81134A-01A

S E R V I C E N O T E

81134A- High Speed Pulse Generator

Serial Numbers: DE42800001-DE42800854

MOTHERBOARD
BACK SIDE VIEW

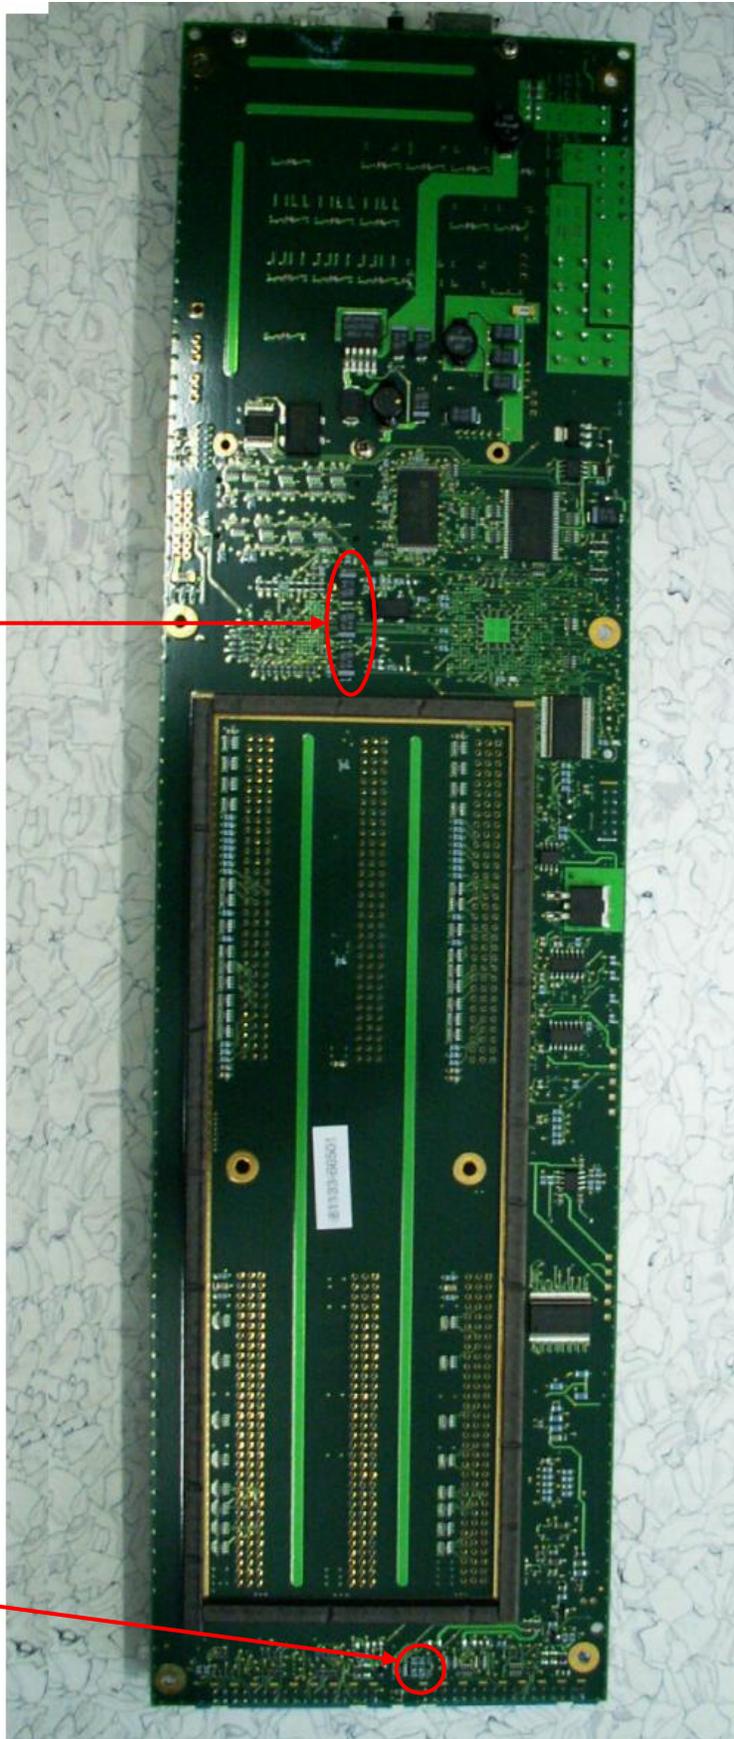
The preventive maintenance to avoid flickering display failures requires removing the 3 capacitors shown in the following picture. And replacing them with new capacitors (part number 0180-4758) while mounting them with the correct polarity.

Polarized Capacitors

Extra Resistors

CLOSE UP VIEW WHERE THE CAPACITORS ARE LOCATED

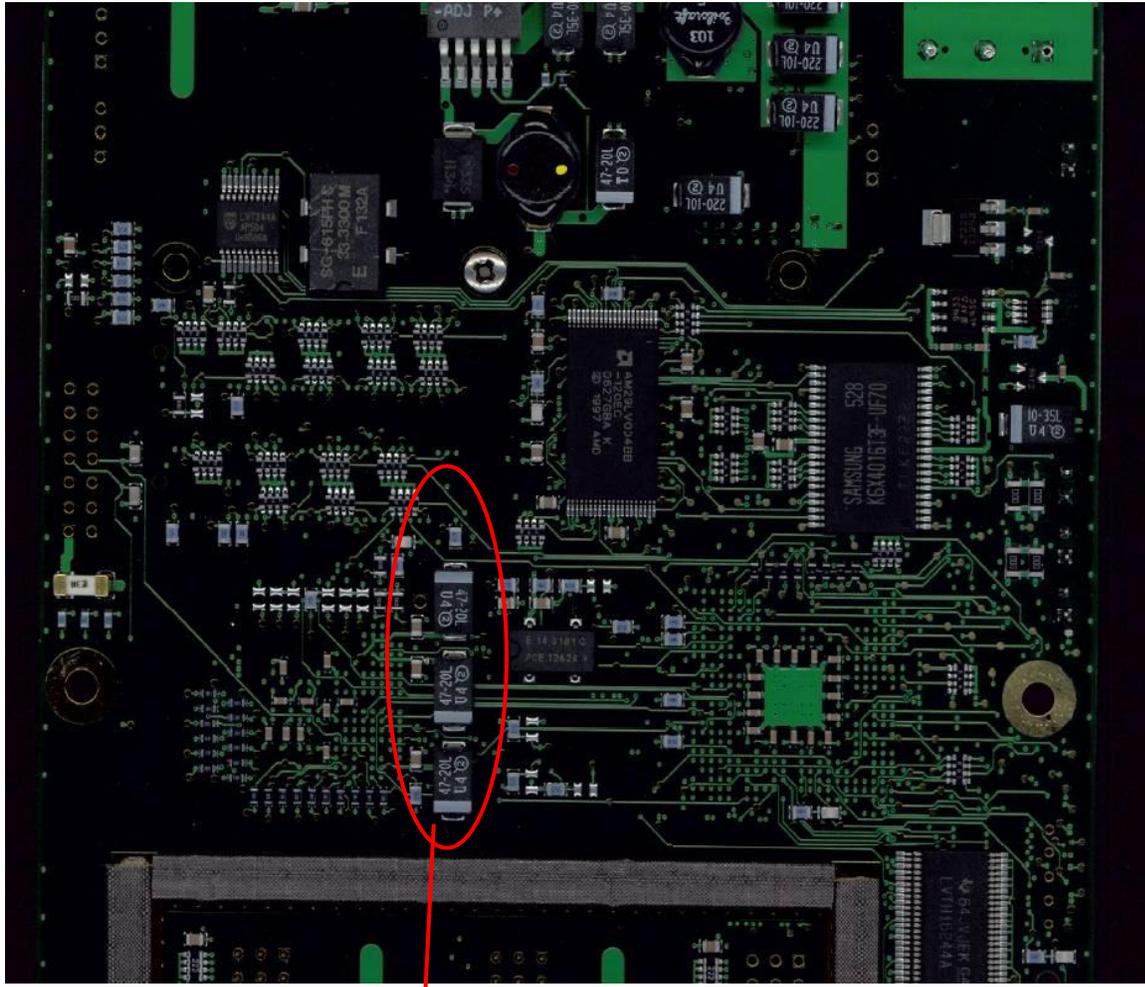
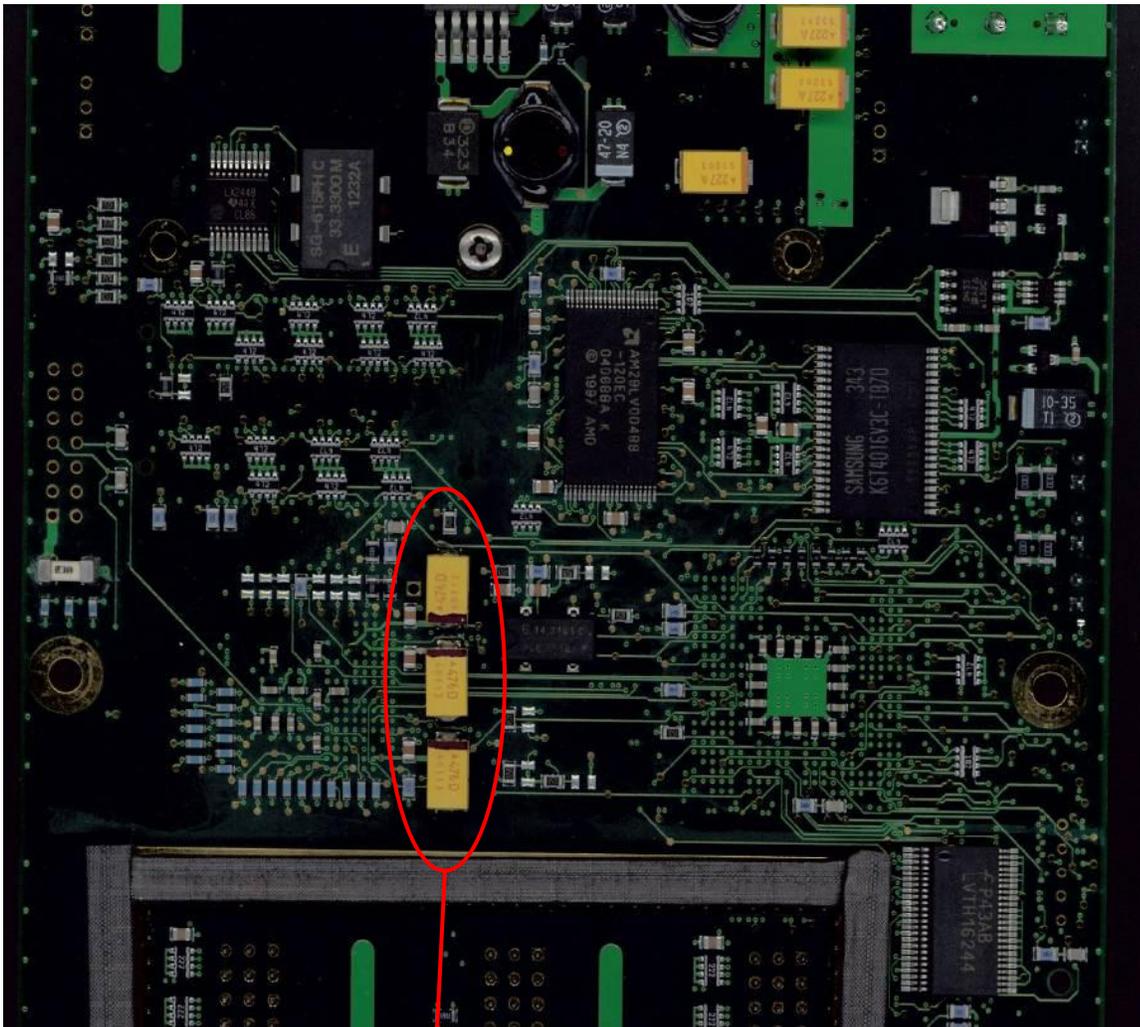
Capacitors mounted with the wrong polarity. The positive side is shown with the white/grey stripe. These 3 capacitors need to be removed.

By applying new capacitors and mounting them with the right polarity failures can be prevented for the future.

This photo shows the capacitors mounted with the right polarity. The positive side is shown with the black stripe. The colors might vary.

CLOSE UP VIEW – THE RESISTORS ARE REMOVED

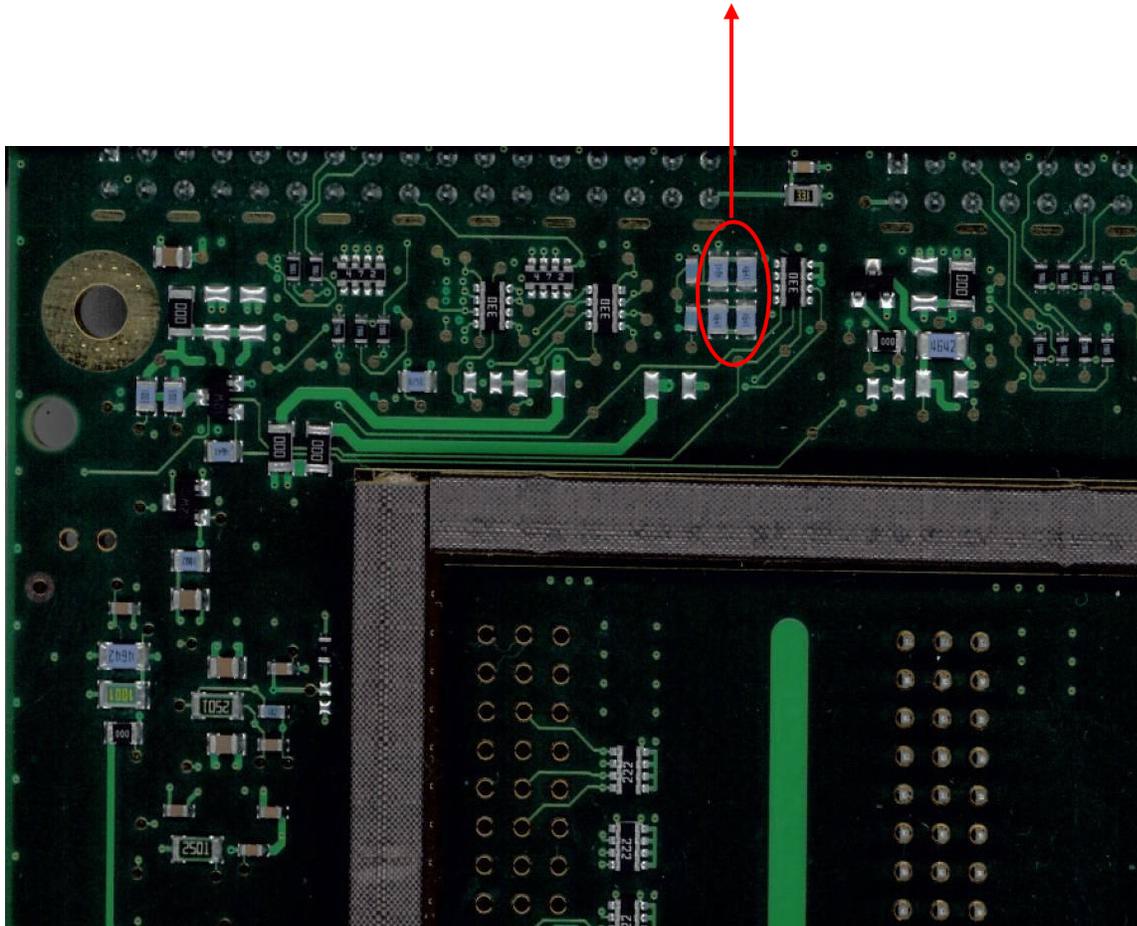
For the preventive maintenance of the know problem the following 4 resistors need to be removed. They are best removed using hot air.

Resistors to be removed (The colours can be different)

The place where the 4 resistors are removed
